<b>Coastal 1b</b>	<b>Approved Development-Access Road</b>
<p>b. Treatment Plant Site Access Road. The access road shall be located along the existing unpaved access road alignment extending from Los Osos Valley Road to the approved development envelope along the eastern property line of the Los Osos Mortuary and Memorial Park site and the western property line of the Andre site in such a manner as to limit its width and overall length as much as possible. The access road shall include measures to effectively screen noise and activity associated with access road traffic and activity from adjacent properties so long as such screen does not itself degrade public views from along Los Osos Valley Road. If the Permittee conclusively demonstrates that the above access road location is infeasible, then the access road shall be located as shown on Exhibit 2 (Exhibit 1-2 Overall Project Site Plan, New Access Road, last dated revised on April 13, 2010, and dated received in the Commission's Central Coast District Office on April 19, 2010) subject to all the same siting and design criteria, and subject to the additional requirement that a mitigation plan for impacts to the agricultural use and

**DRAWING NO. 01C10**

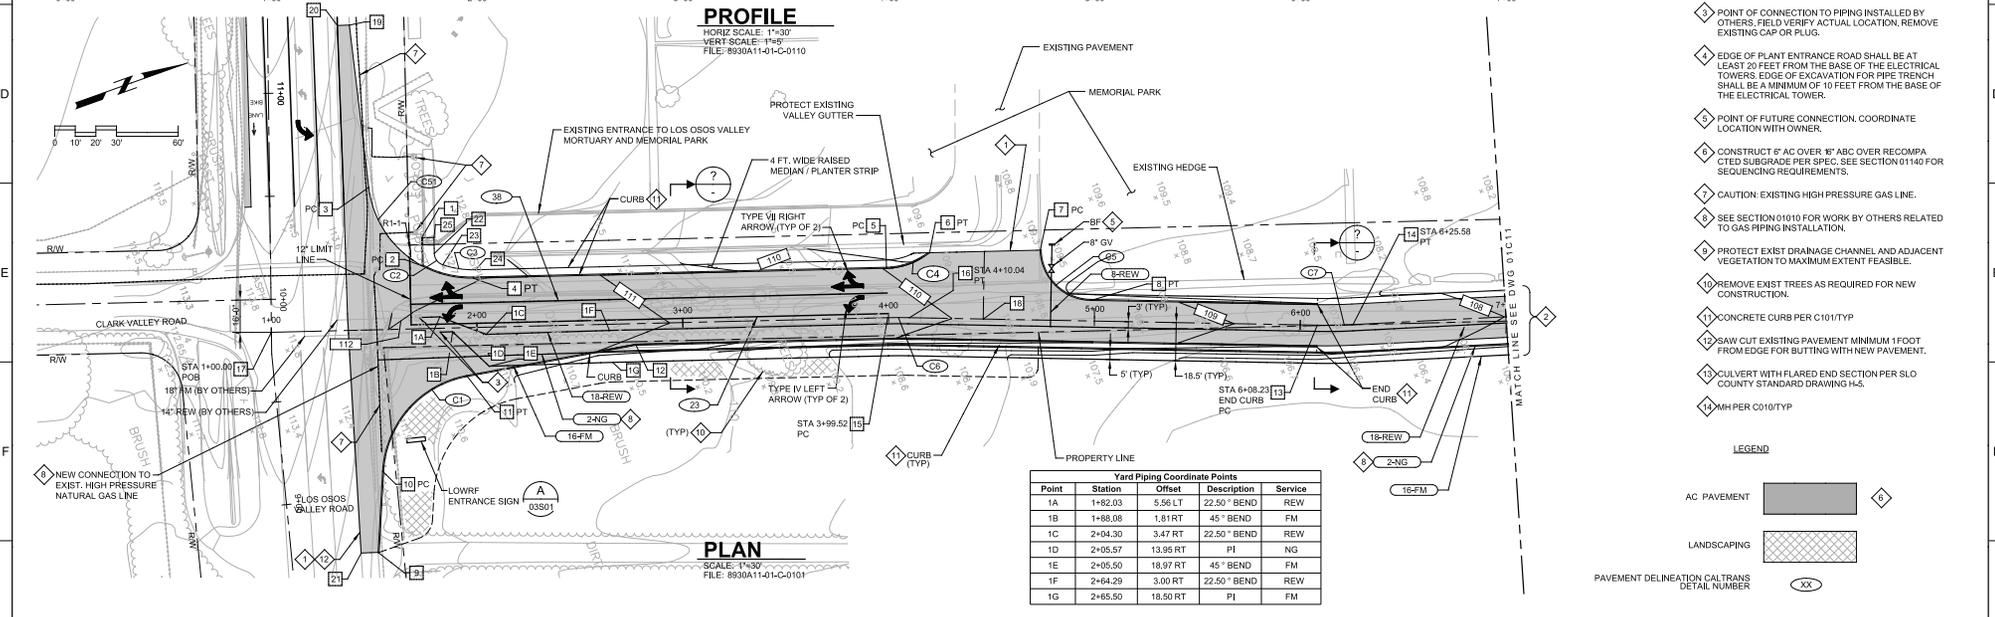
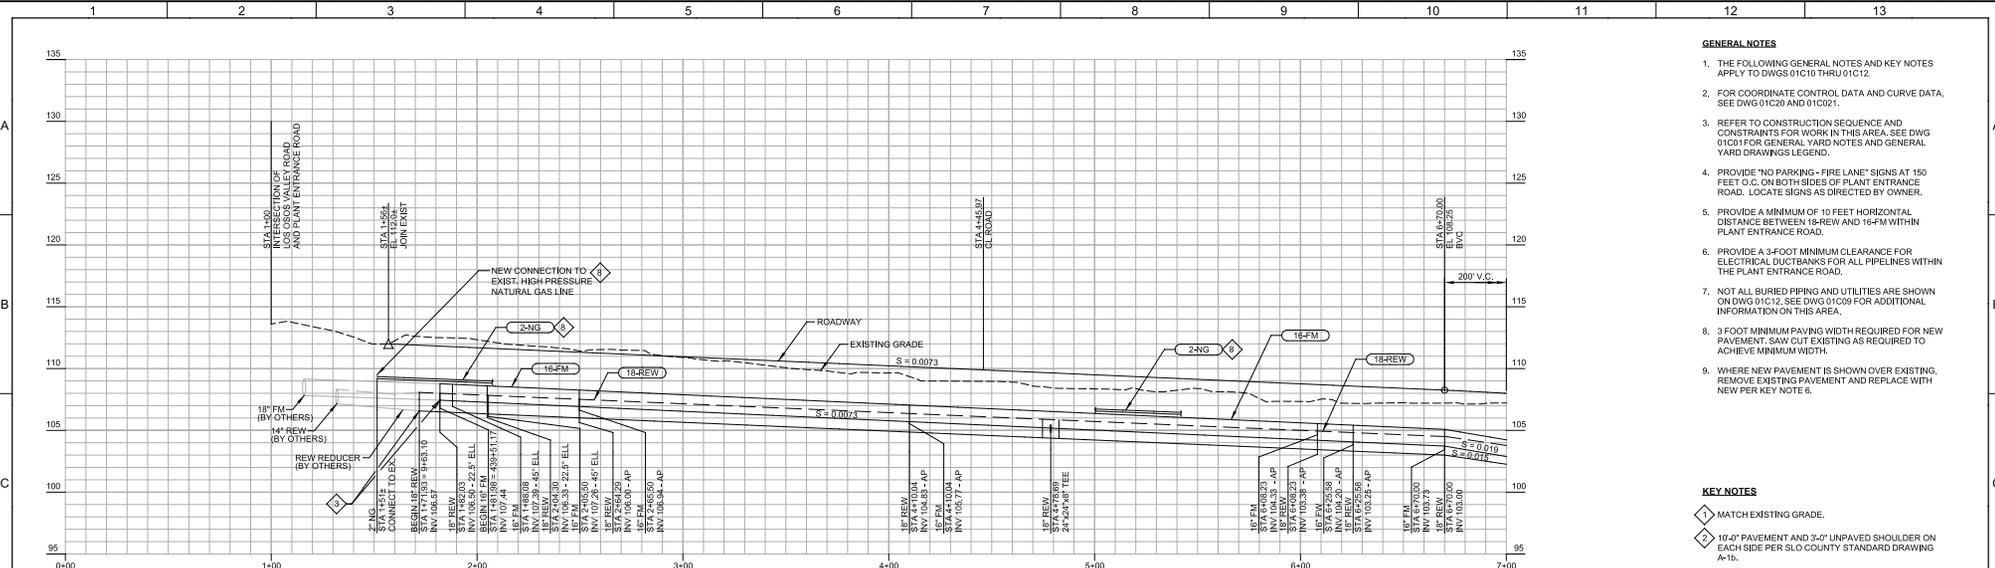
<p><b>Evidence of compliance:</b></p> <p>The access road has been located along the cemetery's eastern property line as shown in Attachment 1. Please note that the location of the access road was based on the following criteria:</p> <ol style="list-style-type: none"> <li>1. Limiting offset from Clark Valley Road to no more than 16 feet as stated in the traffic memo prepared by the County Public Works Transportation Department dated November 9, 2010 (see Attachment 2).</li> <li>2. Minimize impacts to the existing vegetation hedge row along the cemetery's eastern property line.</li> <li>3. Avoiding existing gravestone (gravestone is in the right-of-way). The cemetery owners have requested to leave the grave as-is.</li> </ol> <p>The three existing driveways; 1) mortuary entrance, 2) residential driveway for Andre property, 3) and the access road to the facility site have been combined into a single road entrance. The existing residential driveway to the Andre property (APN 067-031-008) located off of Los Osos Valley Road will be eliminated. The access road to the plant is required to be a minimum of 24 feet wide, to allow safe passage of standard fire safety vehicles and wastewater plant equipment.</p>

Exhibit - Existing Conditions  
10/27/2010

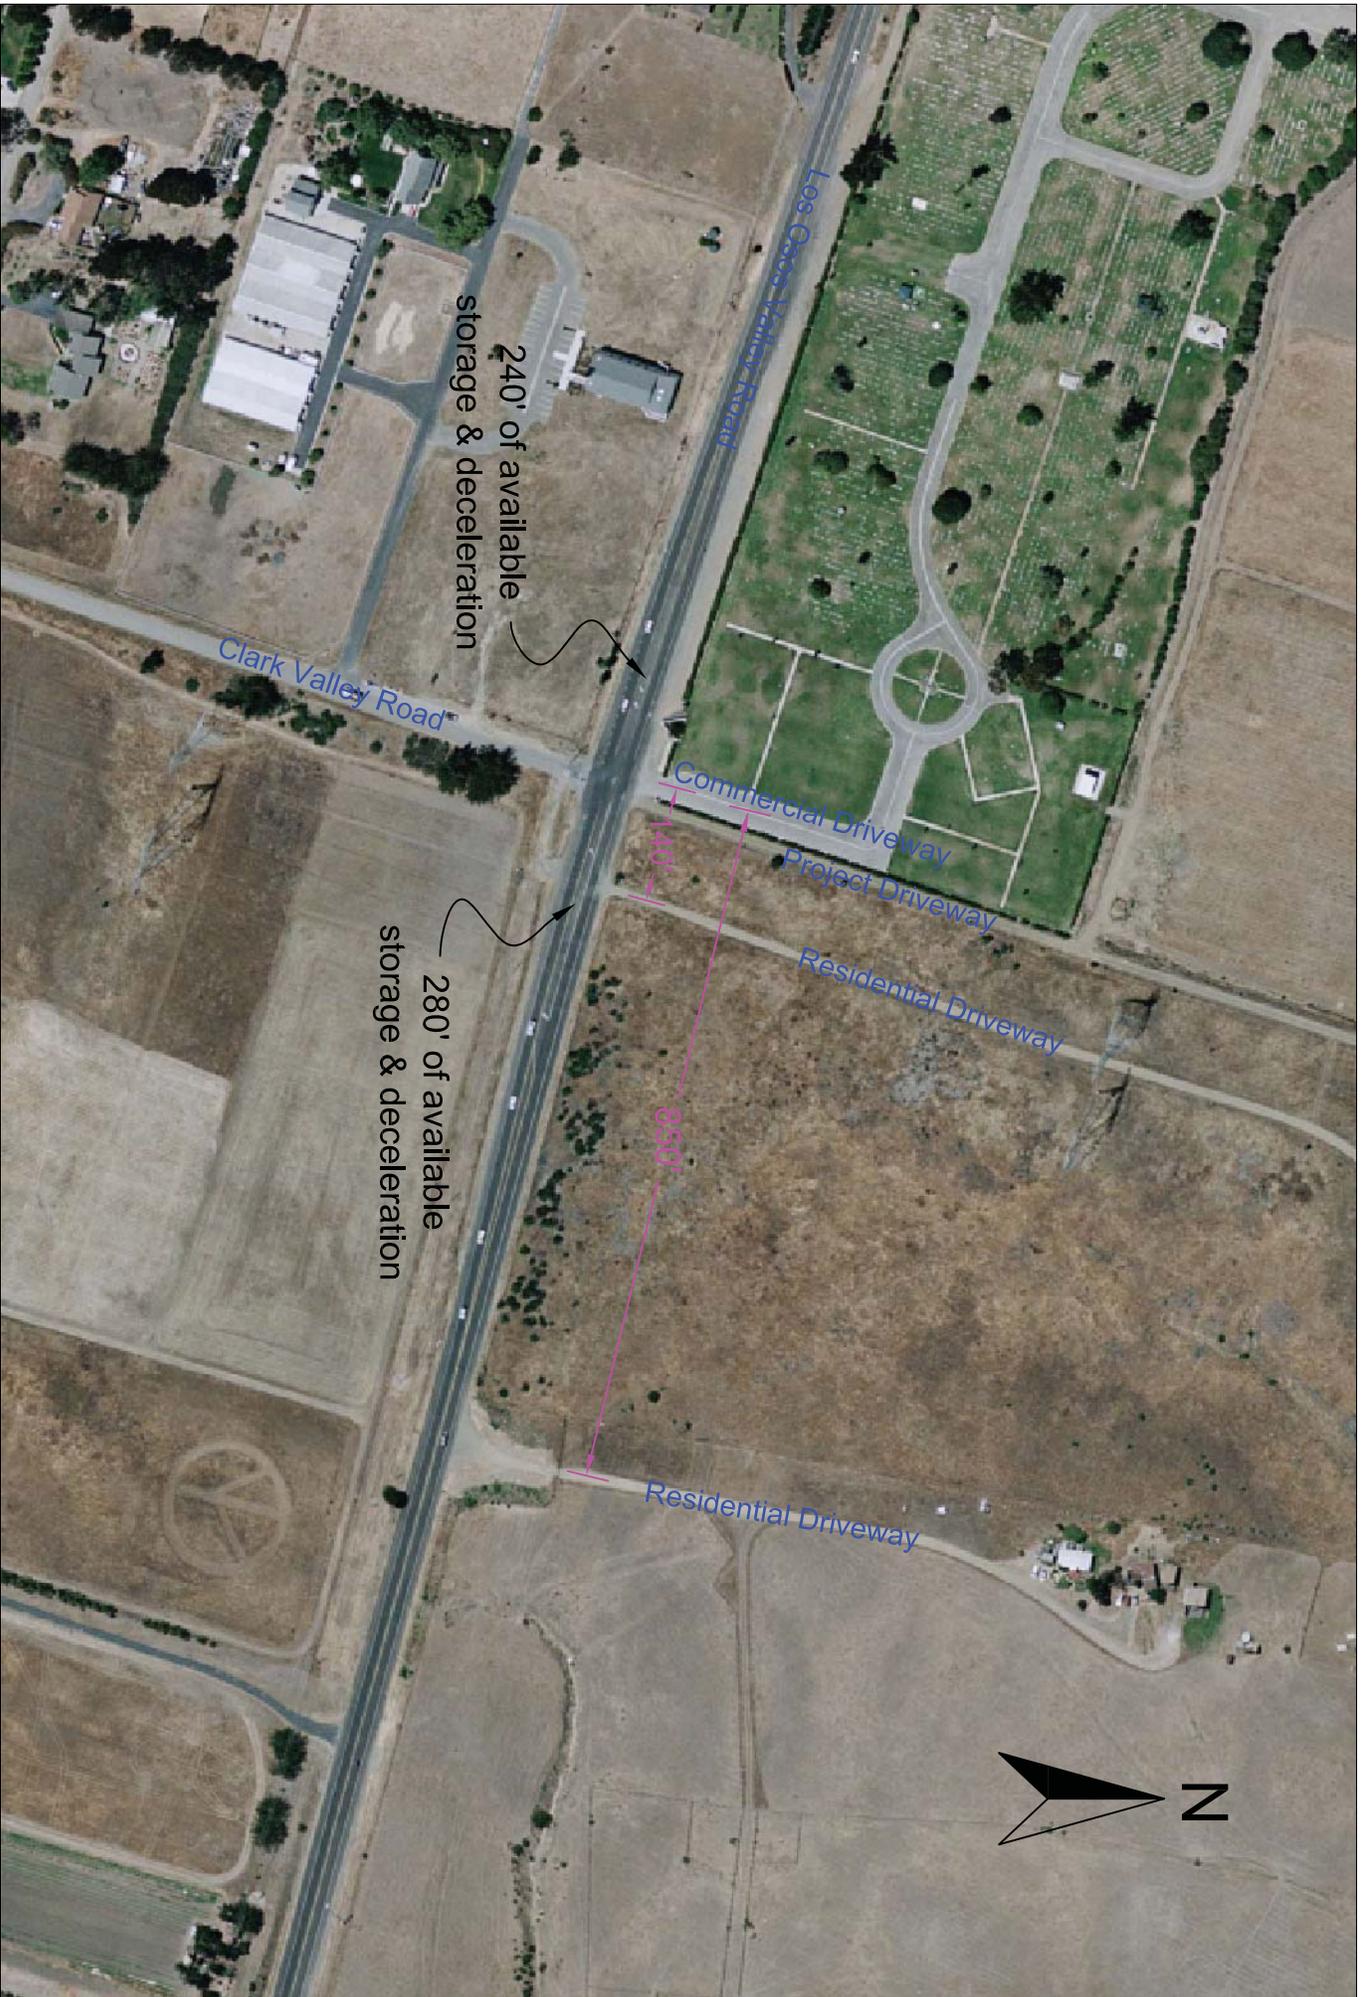
LOVR is a two lane arterial with 4 to 8 foot wide class II bicycle lanes attached. There is a dedicated left turn lane for the intersection of Clarke Valley Road on the southerly side of the road and three driveways on the north side, the Cemetery driveway, a gravel driveway currently accessing the project site, and a residential driveway 140 feet east of the intersection. The attached exhibit details the existing geometric conditions.

The Caltrans Highway Design Manual section 405.1 states that a minimum of 7.5 seconds should be available for corner sight distance. Based on a field review there is

8.7 seconds available east of the existing entrance and 9.5 seconds available to the west of the existing entrance. The current entrance location meets the sight distance criteria.

Currently there are 4 access points onto Los Osos Valley Road within a 150 foot distance. The County Standards (section 4.1.5 E) state that entrances on Arterial roadways should be 200 feet away from the roadway. To accommodate this distance the following would have to occur:

In conjunction with the driveway spacing there are operational impacts caused by offsetting the entrance on LOVR across from Clark Valley Road. A large offset can create additional conflict areas for turning traffic and cause head on accidents for traffic passing through the intersection. In this case, the estimated traffic driving from Clark Valley Road to the entrance is low so the left turn conflicts govern the intersection

Any offset should be made as small as possible and can not be greater than 16 feet. This can be accomplished by either partially reconstructing the intersection of Clarke Valley Road or relocating the entrance per option 2. A topographical survey and preliminary design should be preformed to verify the proposed alignments intersection offset is within these limits.

While Option 1 is preferable due to the good sight distance and ability to keep the entrance across from the Clark Valley Road intersection, either option could meet the criteria with the following elements being addressed:

1. Increase the length of the left turn storage and deceleration lane to 535 feet for the westerly approach of Los Osos Valley Road.
2. Combine the three entrances on the north side of the road into a single shared entrance.
3. Eliminate or minimize the intersection offset between Clark Valley Road and the entrance.
